# dsPIC33EPXXXGP50X, dsPIC33EPXXXMC20X/50X and PIC24EPXXXGP/MC20X

## dsPIC33EPXXXGP50X, dsPIC33EPXXXMC20X/50X and PIC24EPXXXGP/MC20X Family Silicon Errata and Data Sheet Clarification

The dsPIC33EPXXXGP50X, dsPIC33EPXXXMC20X/50X and PIC24EPXXXGP/MC20X family devices that you have received conform functionally to the current Device Data Sheet (DS70000657H), except for the anomalies described in this document.

**FIGURE 1: TIMING DIAGRAMS FOR CENTER-ALIGNED AND EDGE-ALIGNED MODES**

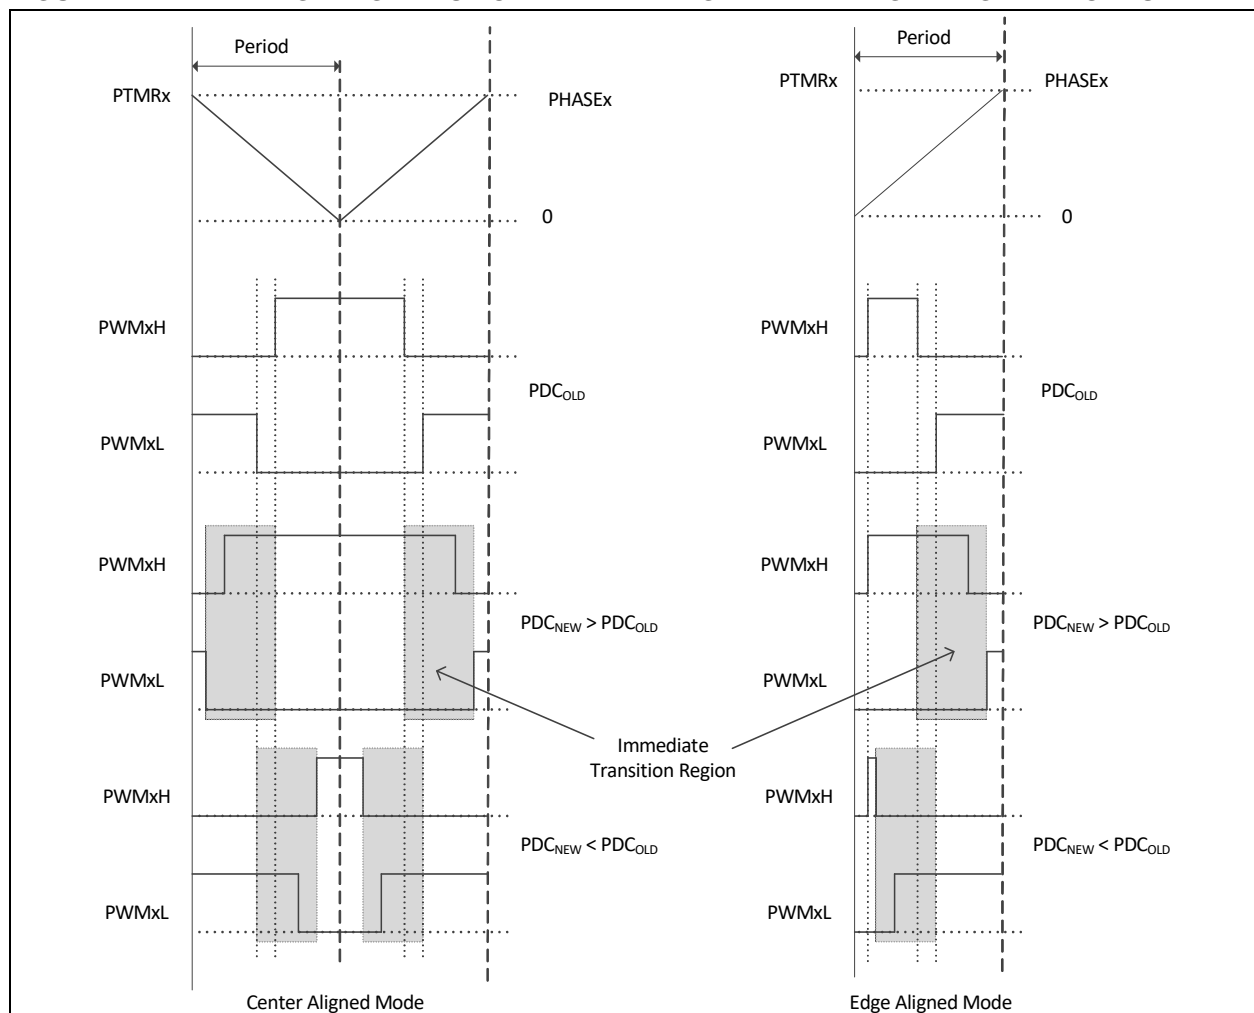
time base, will determine if the PWMxH and PWMxL outputs make an immediate transition. PWMxH and PWMxL outputs make an immediate transition if the Duty Cycle register is written with a new value, PDC<sub>NEW</sub>, at a point of time when the PWM time base is counting a value that is between PDC<sub>NEW</sub> and PDC<sub>OLD</sub>. Additionally, writing to the Duty Cycle register, close to the instant of time where dead time is being applied, may result in a reduced dead time effective on the PWMxH and PWMxL transition edges.

In [Figure 1](#), if the duty cycle write occurred in the shaded box, then PWMxH and PWMxL will make an immediate transition without dead time.

None.

**FIGURE 2: PWM TIMING DIAGRAM**

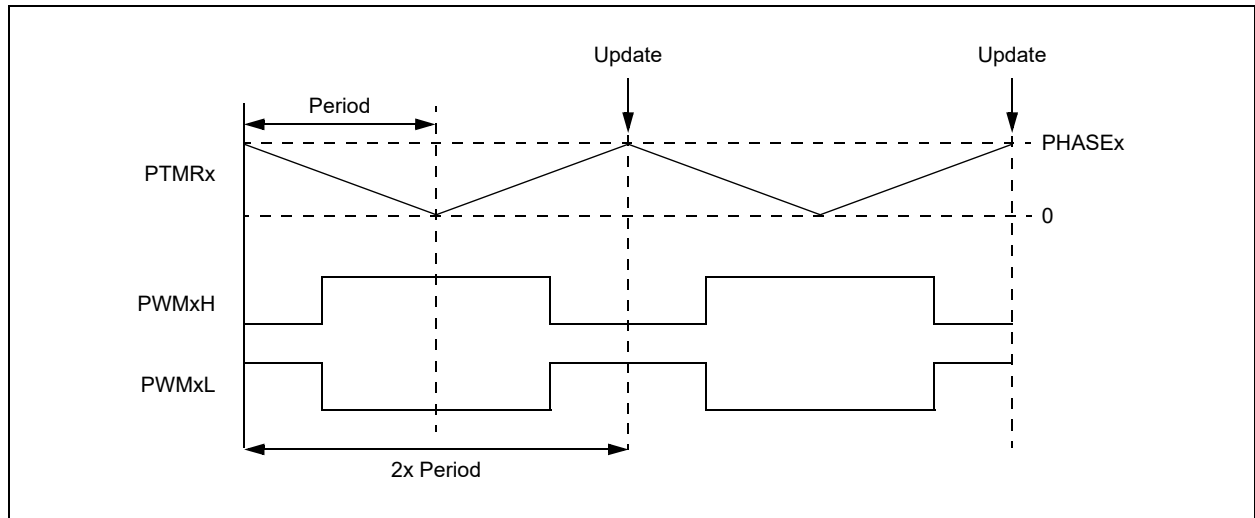
In Center-Aligned mode, updates to active MDC/PDCx/ALTDTRx/PHASEx registers occur only once every two PWM periods; that is, when the PWM timer matches the PHASEx register. In other words, the double update feature is not available. Figure 2 illustrates this relationship.

**FIGURE 3: CORRECT AND INCORRECT POSITION COUNT CAPTURES**

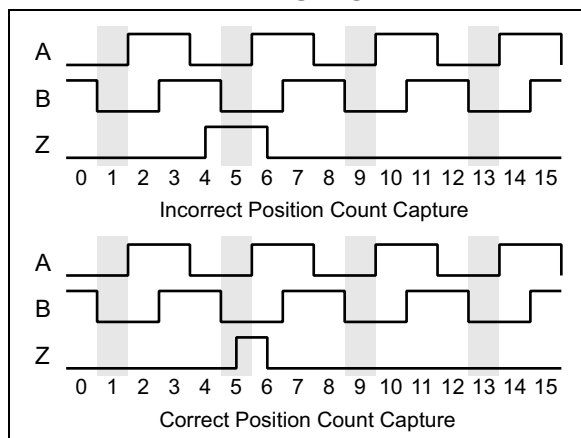
When index count position capture is being used (QEIXOC.QCAPEN = 1), the position count may be one more or one less than the correct value, depending on the direction of the count.

This is only observed when the leading edge of the index pulse occurs prior to the leading edge of the index match event. When the index pulse starts after the leading edge of the index match event, the position count is captured correctly.

Figure 3 shows how this occurs. In these cases, Encoder Signals A, B and (index) Z are shown, with the module being configured for index match when A and B are '0'. The effects of a correct and incorrect capture are shown side by side (shaded area indicates the index match event); the position count is shown along the bottom.

For encoder signals with timing that ensures the index pulse always starts prior to the start of the index match event (i.e., encoders with a non-gated index pulse), measure the direction of the encoder motion. If the encoder is counting up, add one to the captured position count; if the encoder is counting down, subtract one from the captured position count.

For encoder signals where the index pulse leading edge approximately coincides with the start of the index match event (i.e., encoders with a gated index pulse), a small delay can be added to the index pulse, for instance, by using a simple R-C filter.

FIGURE 4: PWM GENERATOR TIMING DIAGRAM

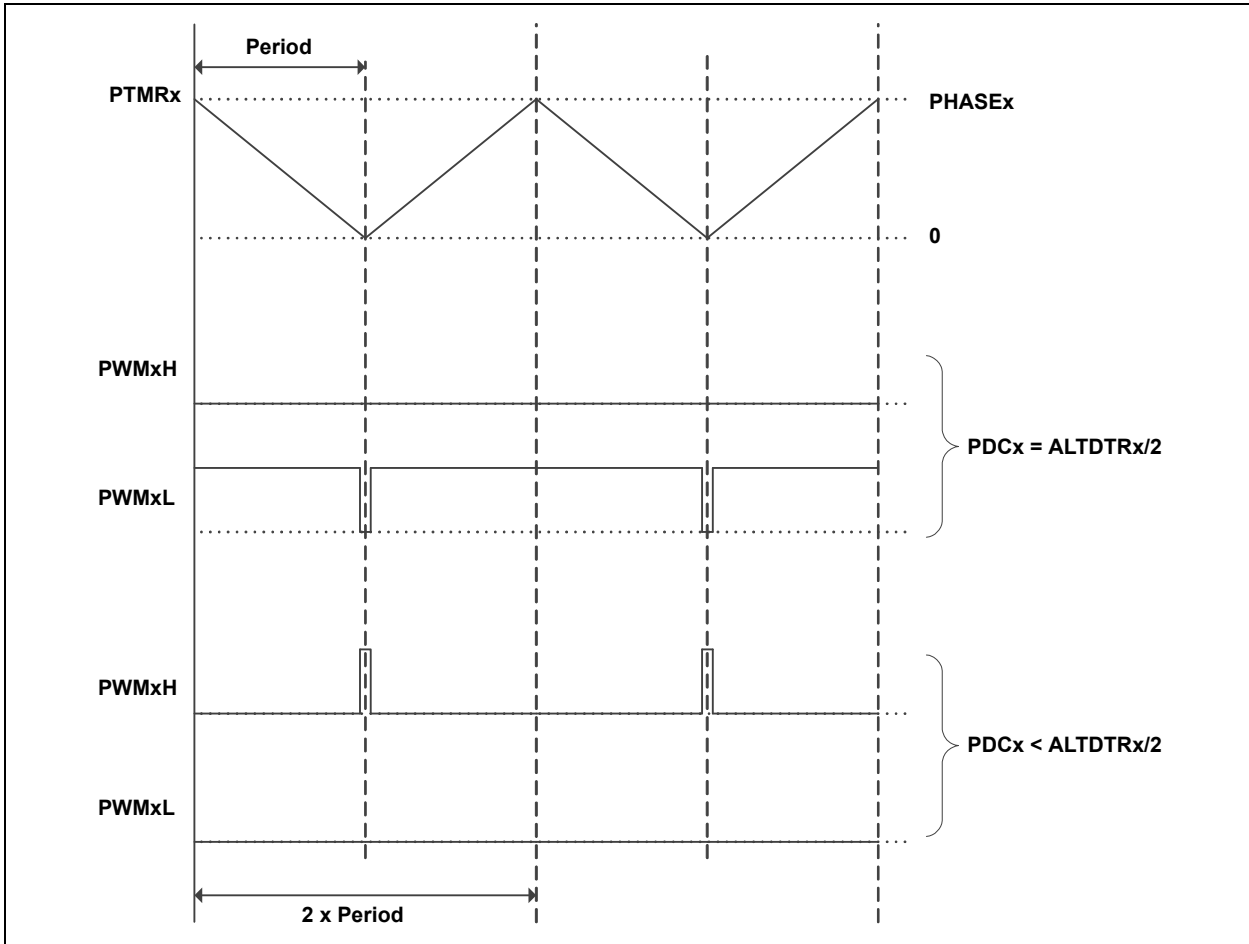
In Center-Aligned Complementary mode with Independent Time Base, if the value in the PDCx register is less than one-half the value in the ALTDTRx register, the PWM generator will force the PWMxL to low, and on the PWMxH, generate pulses of width less than twice the dead time, as shown in Figure 4.

**FIGURE 5: ILLUSTRATION OF 1 T<sub>osc</sub> GLITCH WHEN PWM OVERRIDE IS TURNED OFF**

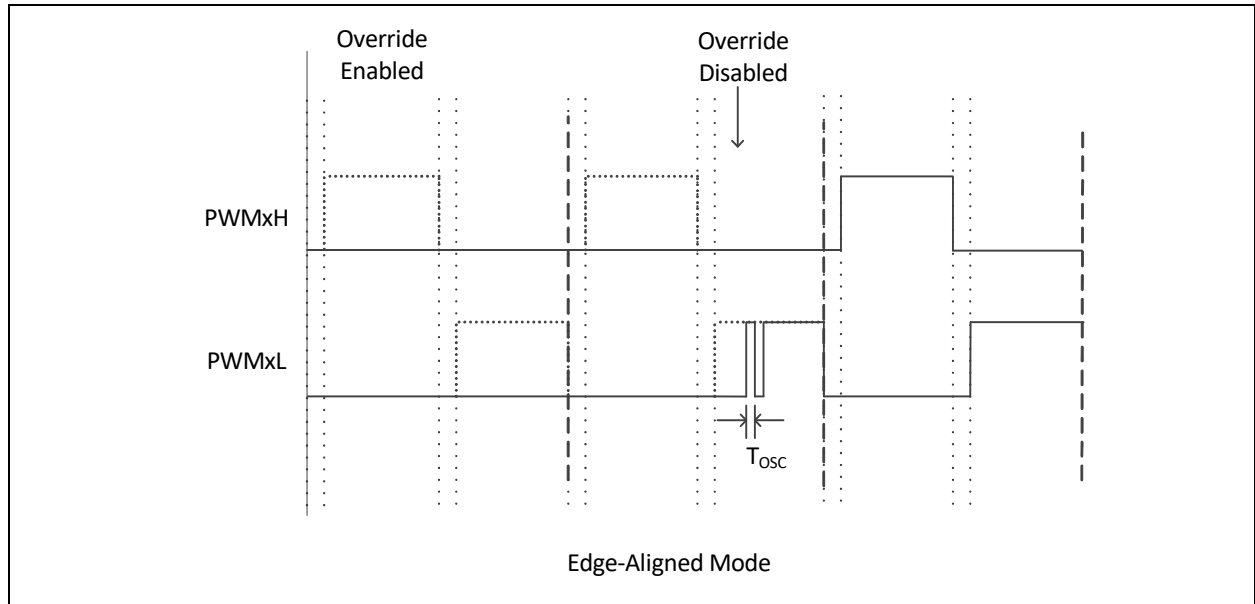
In Complementary mode after the PWMx module is enabled (PTEN = 1), if the PWM override is turned off, a 1 T<sub>osc</sub> glitch will be present on the rising edge of either PWMxH or PWMxL, whichever occurs first, as shown in Figure 5. The glitch will be present on PWMxH/PWMxL every time the override state is changed from enabled to disabled. The width of this glitch is equal to 1 T<sub>osc</sub> when PCLKDIV[2:0] = 000; increasing the PWM input clock prescaler setting will increase the width of the glitch accordingly.

**FIGURE 6:**

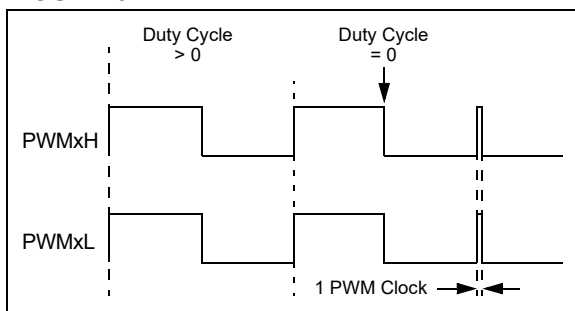
In certain output modes, the PWMx module produces a pulse glitch of one PWM clock in width (Figure 6). This has been observed only when all of the following are true:

- Either Redundant or Push-Pull Output mode is selected (IOCONx[11:10] = 10 or 01);
- Immediate Update is disabled (PWMCONx[0] = 0); and
- The value of the current Duty Cycle register (either the PDCx or MDC register, as determined by PWMCONx[8]) is updated to zero from any non-zero value.

The pulse glitch has been observed to occur at the beginning of the following PWM boundary period.

**FIGURE 7:**

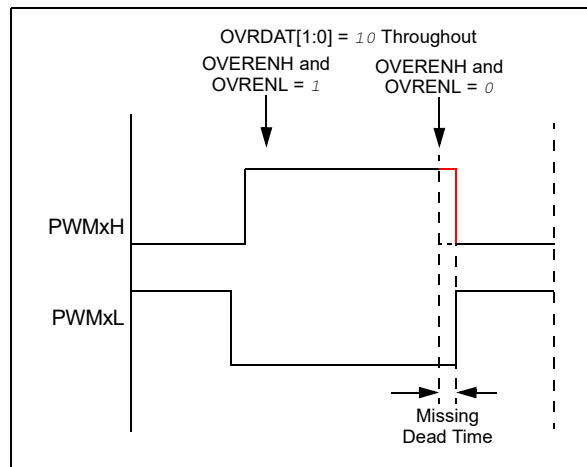
- Output override synchronization is configured to occur on the CPU clock boundary (IOCONx[0] = 0);
- Both PWMxH and PWMxL overrides are enabled prior to the event (OVRENH and OVRENL are both '1'), and
- Both overrides are disabled (OVRENH and OVRENL are both '0') at the instant the dead time should be asserted (Figure 7).

This has been observed in both Center-Aligned and Edge-Aligned modes.

**FIGURE 8:**

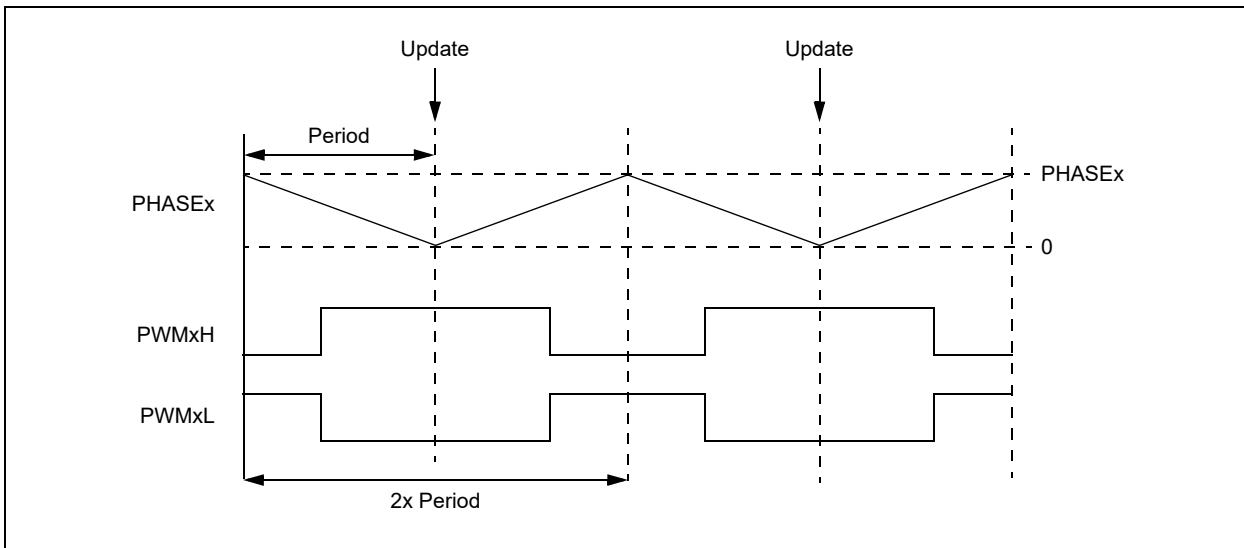
In Center-Aligned Complementary mode with Independent Time Base, updates to the PHASEx register take effect in the middle of a center-aligned PWM cycle, as shown in Figure 8. This occurs only when the Immediate Update feature is disabled (IUE = 0). If Immediate Update is enabled (IUE = 1), the PHASEx register updates will take effect immediately.

**FIGURE 9: SIMPLIFIED BEHAVIOR**

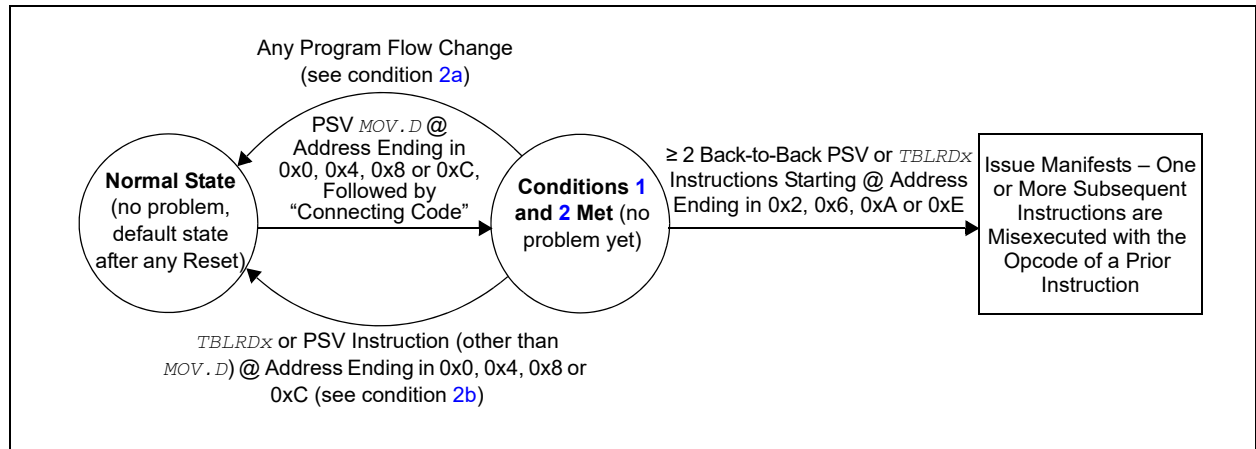
3.	≥ 2 back-to-back PSV or <i>TBLRDx</i> instructions are executed (following the code of condition 2), where the first of the back-to-back instructions is located at an address ending in 0x2, 0x6, 0xA or 0xE.

Figure 9 provides an example of the effective behavior.

1. All instances of PSV *MOV.D* can be replaced with two PSV *MOV* instructions instead. Non-PSV *MOV.D* instructions acting on RAM/SFRs do not need to be modified; or
2. If not already present, a program flow change instruction (such as *BRA \$+2*) can be inserted above back-to-back data Flash read sequences; or
3. Back-to-back data Flash read instruction sequences can be broken up by inserting a non-Flash read instruction (such as a *NOP*) in between the Flash read instructions; or
4. The alignment of the code can be shifted to avoid the required opcode location addresses.

C code built with MPLAB® XC16 Compiler, Version 1.32, or later, implements the work around by default. However, if the application uses Assembly language routines, these should be manually modified to implement the work around. Additionally, if precompiled libraries are used, these should be built with XC16 Version 1.32 or later. For additional information, please visit: [www.microchip.com/erratum\\_psrds\\_psrds](http://www.microchip.com/erratum_psrds_psrds).

**FIGURE 32-10: TYPICAL LPRC FREQUENCY @ VDD = 3.3V**

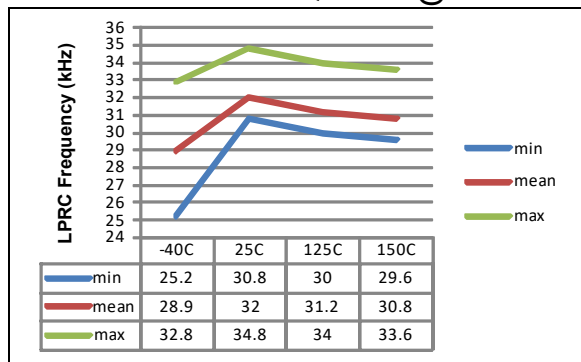
The typical LPRC frequency plot over temperature at VDD = 3.3V has been corrected, as shown in Figure 32-10 below.

**FIGURE 25-1: OP AMP/COMPARATOR x MODULE BLOCK DIAGRAM (MODULES 1, 2 AND 3)**

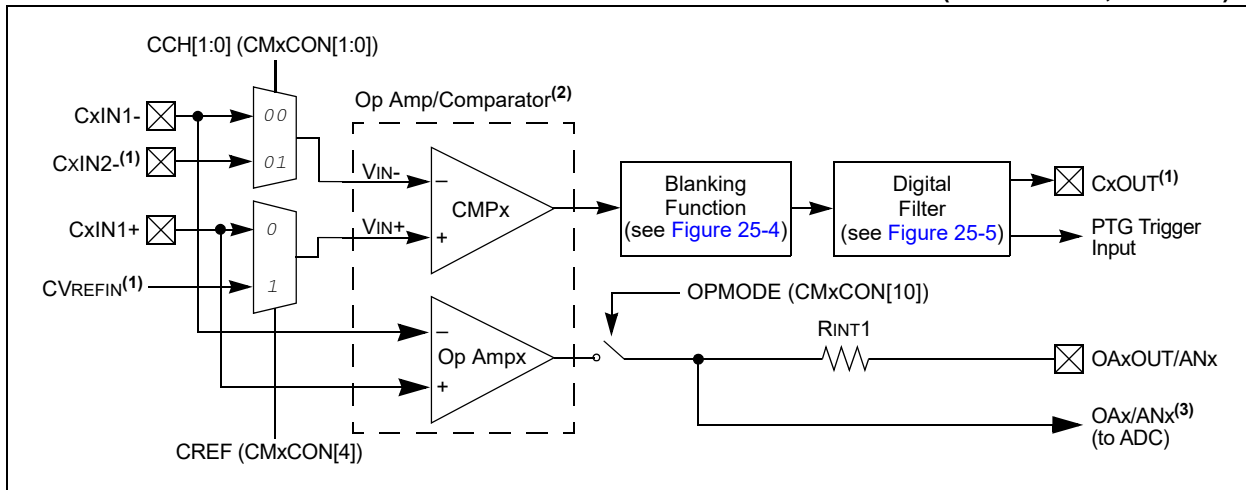
Figure 25-1 (shown below) is corrected to show that the op amp in these modules obtains its inverting and non-inverting inputs directly from the CxIN1-/1+ pins. The operation of the actual module is unchanged. (Footnotes in the original are unchanged, but are removed here for clarity.)
